M54 to M6 Link Road
TR010054

**8.8 LIU(C) Draft Statement of Common
Ground with Robert Edward Rowe**

**8.8 LIU(C) Draft Statement of Common Ground with
Robert Edward Rowe**

STATEMENT OF COMMON GROUND

Appendix B – Fencing drawing

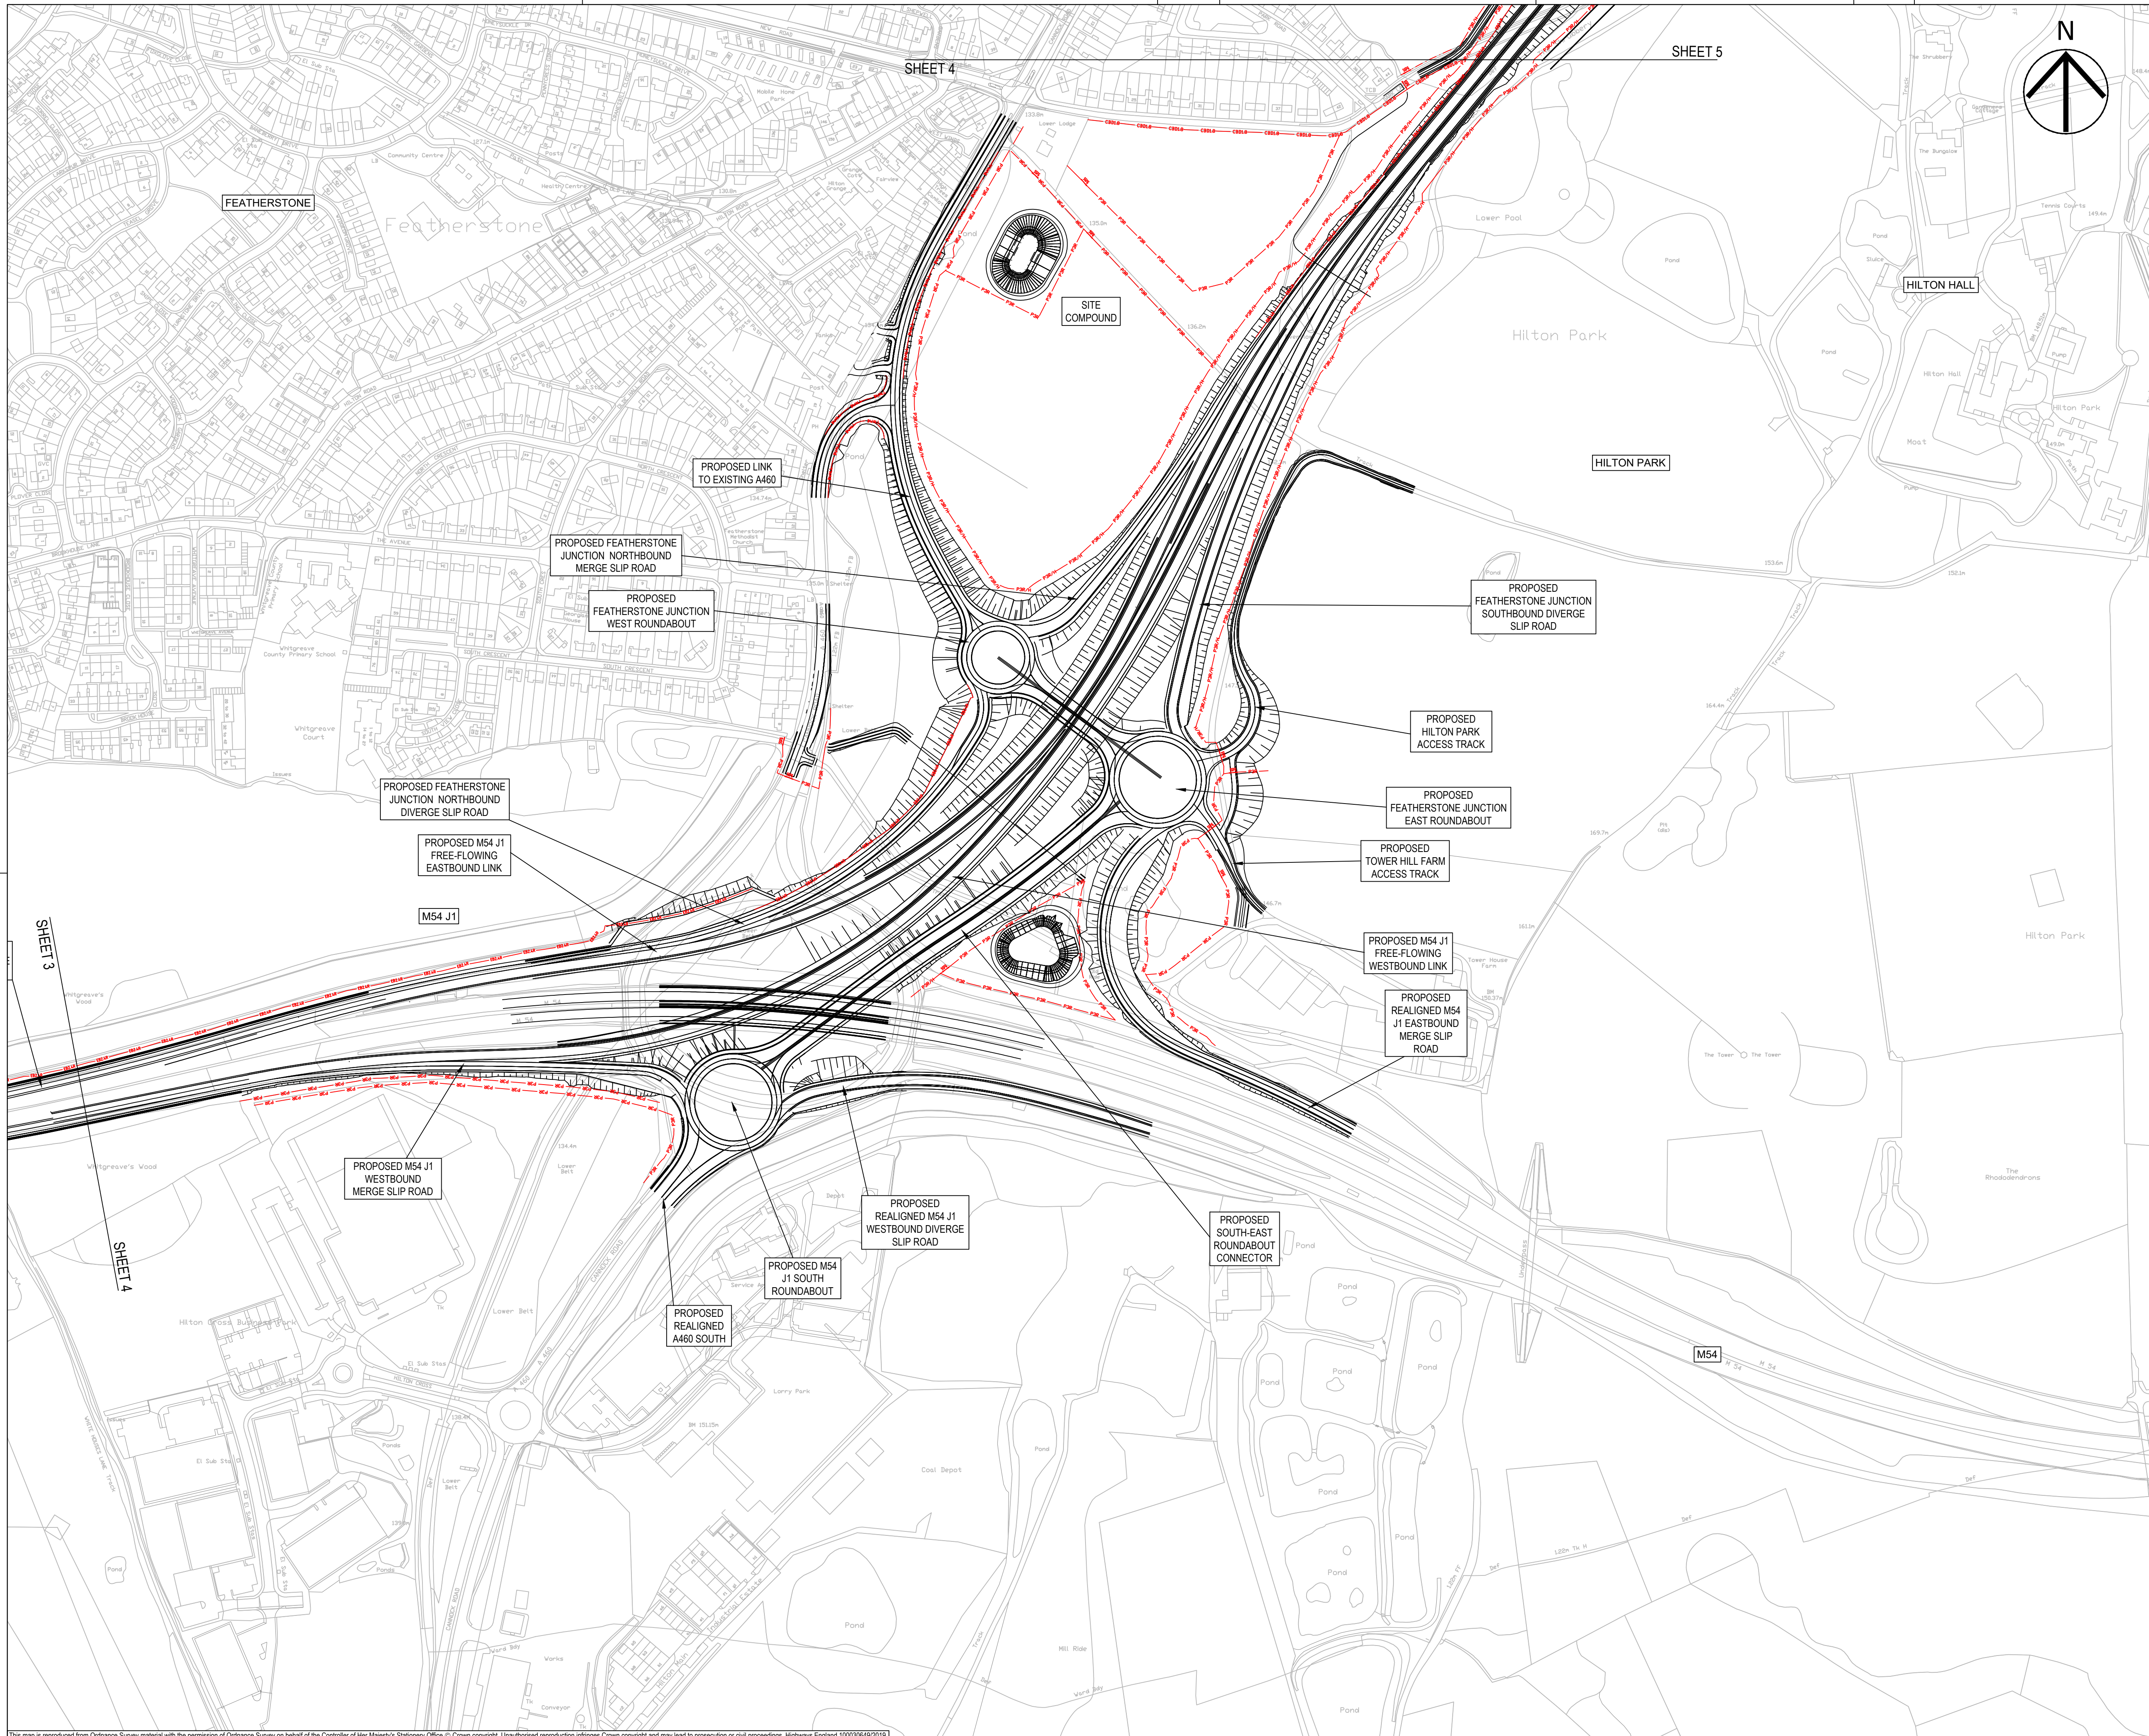
Document/Meeting	Landowner Comment	Highways England Response	Status	Agreement likely (app) ¹	Agreement likely (IP)
Landowner meeting 4th November 2019	Internal northern access track required to remove need for farm vehicles to use public highway.	An internal access track has been added to the design.	Agreed	Agreed	Agreed
	Private accesses from roundabout requested to be gated.	Highways England can confirm the private access off the proposed new A460 roundabout to Tower House Farm will be gated. See Appendix B for the fencing drawing (Ref [HE514465-ACM-HFE-Z2_SW_PR_Z-DR-CH-1004]). The exact	Under discussion	High

specification of the gates is to be confirmed following detailed design.			
	Landowner is concerned the new proposed layout of the yard will create restricted access and operational issues.	<p>Highways England has noted the Landowner's concerns and in response has proposed a change to the alignment of the slip road leading on to the M54 eastbound to reduce the impact on the yard at Tower House Farm (change 6 in the documents submitted to the Planning Inspectorate on 9 October 2020). The proposed alignment would minimise the amount of required land take in the yard to just the very south-western corner and will retain more of the existing access track along the southern boundary of the yard.</p> <p>Furthermore, Highways England has incorporated a forked access to the Tower House Farm yard to assist with vehicles turning in the yard and removing the need for an additional turning head, this was discussed at a meeting with the landowner on 10/03/2020. This change was incorporated into the design prior to submission of the DCO application in January 2020.</p> <p>Therefore, it is considered that the impact on the yard has been minimised and HGVs and motorhomes will be able to continue to</p>	Under discussion	High
